WOLF CREEK
NUCLEAR OPERATING CORPORATION

ET 08-0022

Subject: Docket No. 50-482: Wolf Creek Nuclear Operating Corporation
Response to Open Items Associated with the NRC Draft Safety
Evaluation for the Wolf Creek Generating Station Application for License
Renewal

Simplified electrical one-line diagram of the Wolf Creek Generating Station
345 kV switchyard

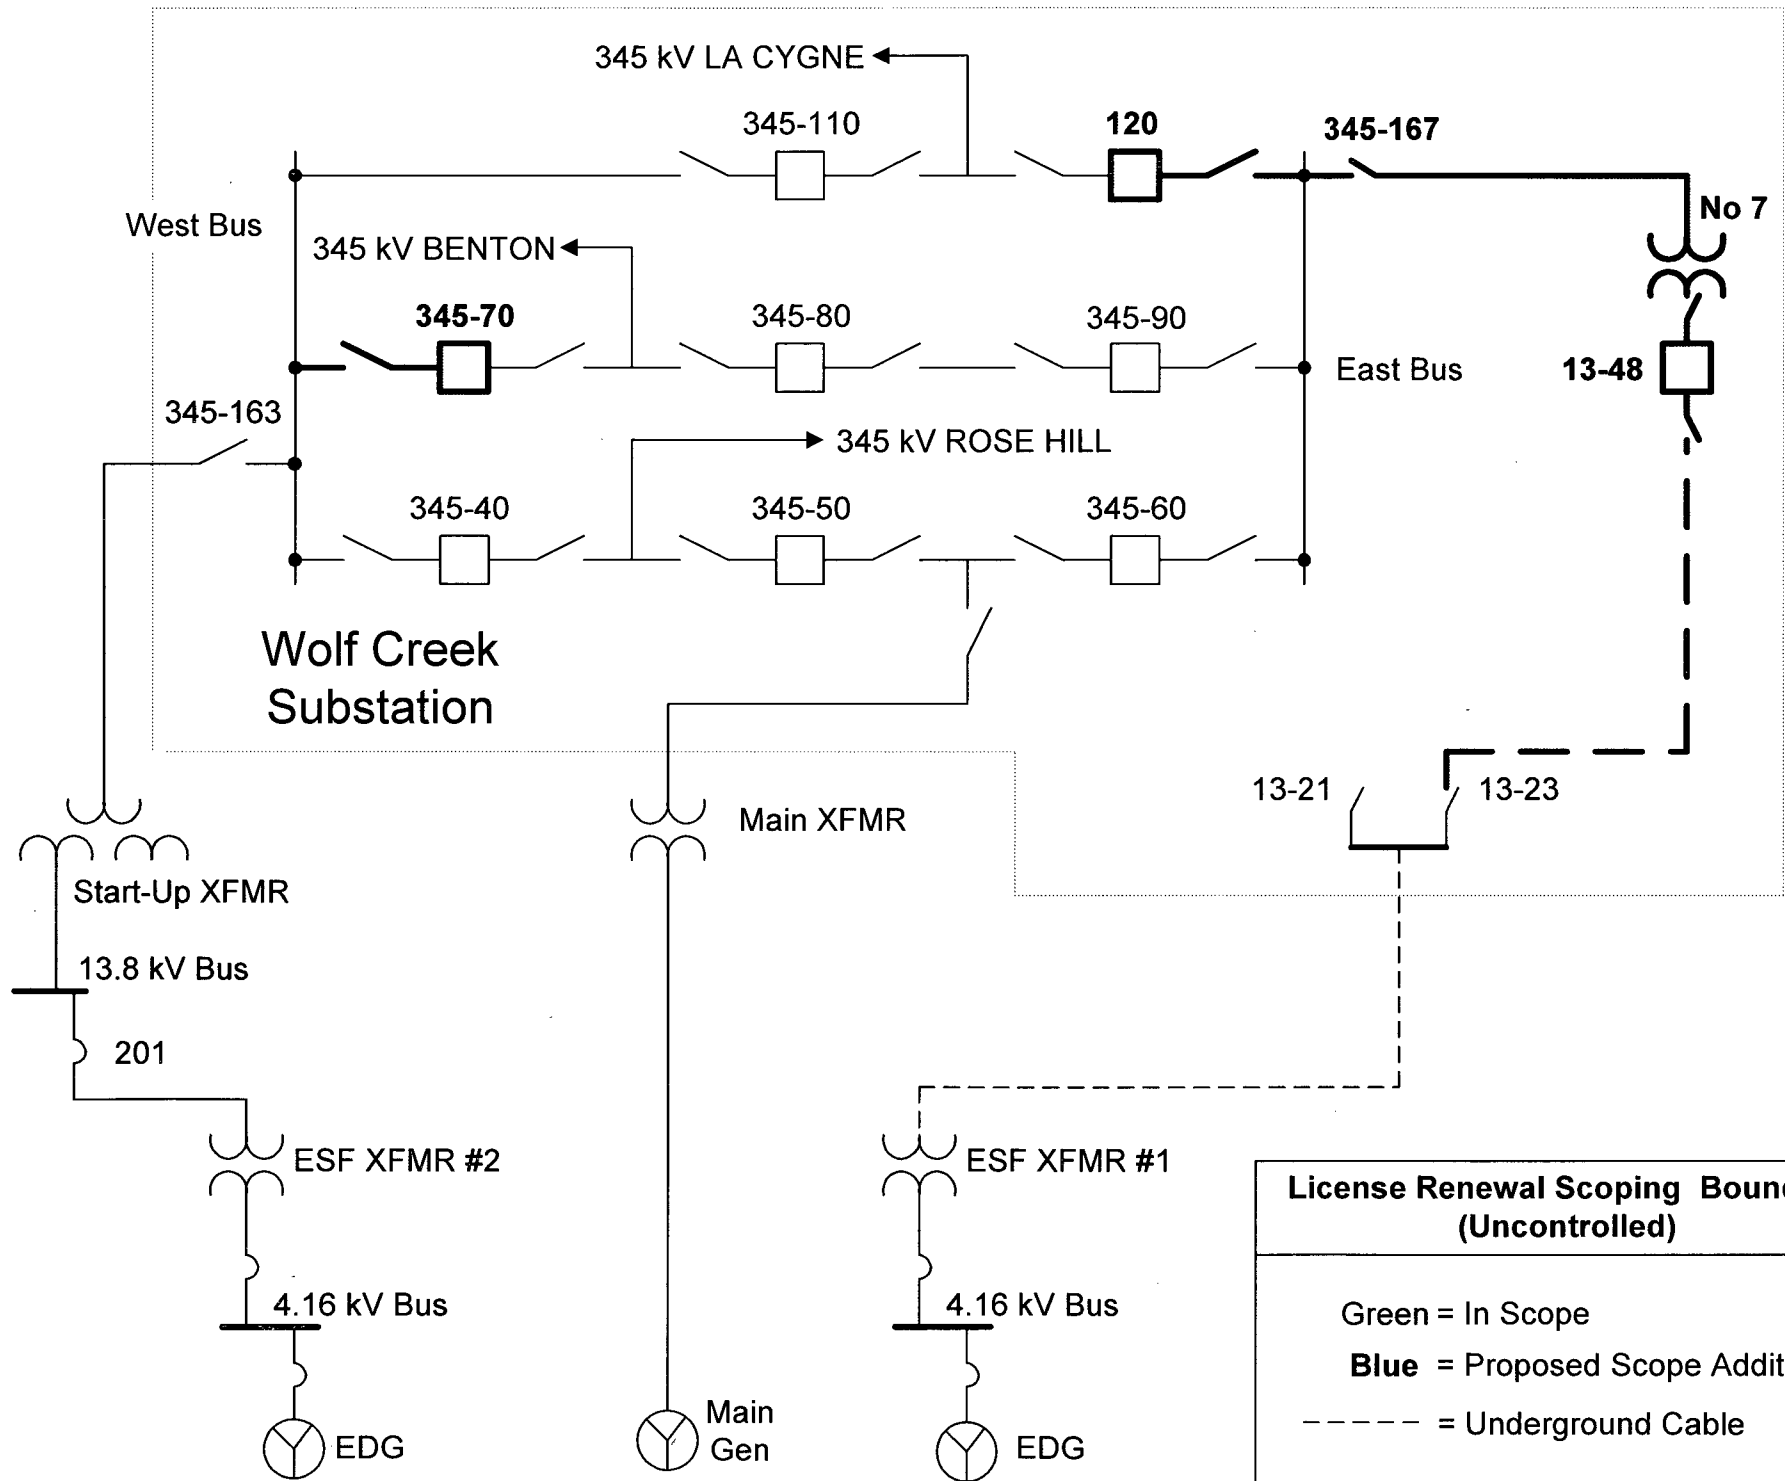
Information provided by the applicant for equipment relied on to meet the requirements of the station blackout (SBO) rule (10 CFR 50.63) for license renewal (10 CFR 54.4(a)(3)) is inconsistent with the staff review criteria. Hence, the applicant should include the circuits up to and including the switchyard circuit breakers used for SBO recovery within the scope of license renewal.

As an aid for the discussion in response to open item 2.5-1, Enclosure 1 provides a simplified electrical one-line diagram of the Wolf Creek Generating Station (WCGS) 345 kV switchyard. The WCGS switchyard has eight (8) 2000 Amp rated line and generator breakers, connected in a breaker and a half scheme.

The primary SBO recovery lineup for safety circuits train B is up through ESF Transformer # 2, through plant breaker 201 to 13.8 kV bus feed from the start-up transformer secondary. The start-up transformer is included in the recovery path and is connected via a short overhead tie line to the West 345 kV bus via normally closed disconnect switch 345-163.

The secondary SBO recovery lineup for safety circuits train A is through ESF Transformer # 1, up through normally closed disconnect switch 13-23. As part of the License Renewal resolution to open item 3.0.3.1.10-1, WCNOG is proposing to include the underground cable from the normally closed disconnect switch 13-23 up to and including switchyard breaker 13-48. Additionally WCNOG has included in the proposal, to resolve open item 2.5-1, the No. 7 transformer and overhead 345 kV bus leads up to the East 345 kV Switchyard Bus, which also includes normally closed disconnect switch 345-167.

To address the NRC's March 5, 2008 issuance of "Proposed License Renewal Interim Staff Guidance LR-ISG-2008-01: Staff Guidance Regarding the Station Blackout Rule (10 CFR 50.63) Associated with License Renewal Applications," WCNOG has scoped into License Renewal two 345 kV breakers. For the primary SBO recovery path involving the start-up transformer, 345 kV switchyard breaker 345-70 is identified as the scoped breaker. For secondary SBO recovery path involving ESF Transformer #1, 345 kV switchyard breaker 345-120 is the identified as the scoped breaker. Both 345 kV breaker lineups are completed utilizing normal coordination with the Westar Energy transmission operator responsible for system blackout restoration. The changes to the license renewal scope to resolve Open Item 2.5-1 have been submitted as an Amendment to the License Renewal Application under separate letter.

Plant breaker 201 provides protection of downstream safety circuits train B, for the primary SBO recovery lineup from the West Bus through the start-up transformer.

Breaker 201 is designed to protect for start-up transformer faults, West 345 kV and overhead tie line faults, feeder cable faults from breaker 201 to ESF #2 transformer and ESF # 2 transformer faults.

Switchyard breaker 13-48 provides protection for downstream safety circuits train A in the secondary SBO recovery lineup from the East Bus through No. 7 transformer.

Breaker 13-48 is designed to protect for No. 7 transformer faults, East 345 kV and lead line faults, underground cable faults to ESF #1 transformer and ESF #1 transformer faults.

1. Plant breaker 201 and switchyard breaker 13-48 provide protection for downstream safety circuits.
2. Plant operator control for energization and de-energization of safety circuits is accomplished by plant operator control of breaker 201 and switchyard breaker 13-48.
3. Closing plant breaker 201 or switchyard breaker 13-48 accomplishes SBO recovery lineups.

As noted in the Response to OI 2.5-1, WCNOC has included the inaccessible medium voltage switchyard cable from disconnect 13-23 up to breaker 13-48 in the scope of license renewal. The Aging Management Program related to Inaccessible Medium Voltage Cables Not Subject to 10 CFR 50.49, Environmental Qualification Requirements applies to this cable. The changes to the license renewal scope to resolve Open Item 3.0.3.1.10-1 have been submitted as an Amendment to the License Renewal Application under separate letter.
